## X-300 firmware version 3.022E

This zipped folder contains the files and instructions to upgrade your X-300 fluxer with the current firmware (operating system) version 3.022E.

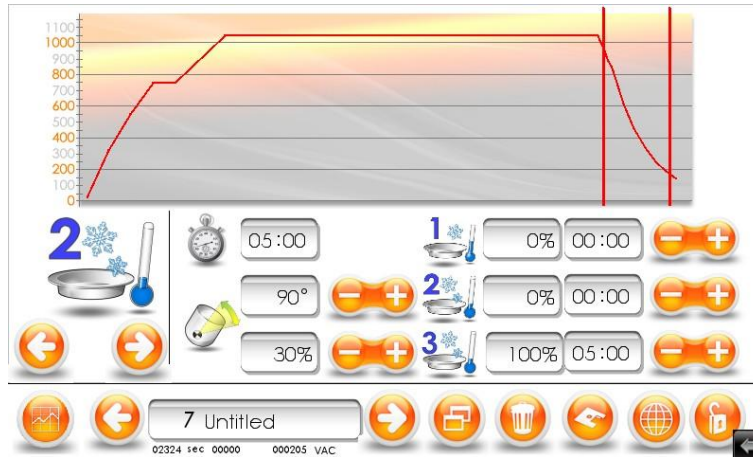
- New "Data Sampling" feature added. It gives the ability to log every fusion cycle with the samples IDs and generate a separate report for each day, up to a possibility of 40 days data recovery.

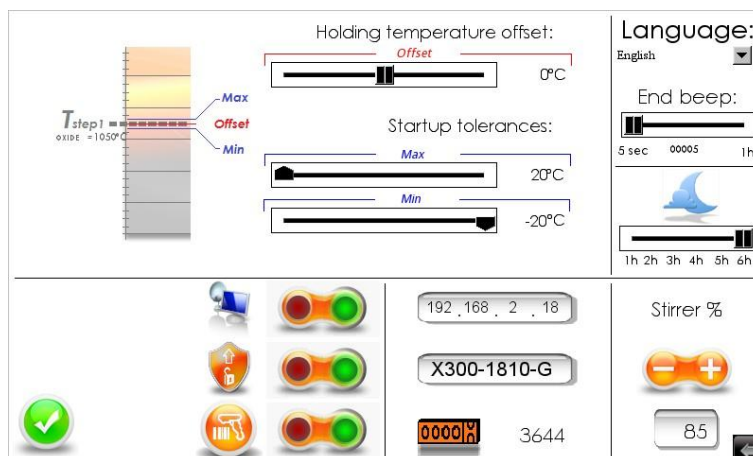
- New information fields, showing the serial number of the unit and the fusion counter in the global parameter window.
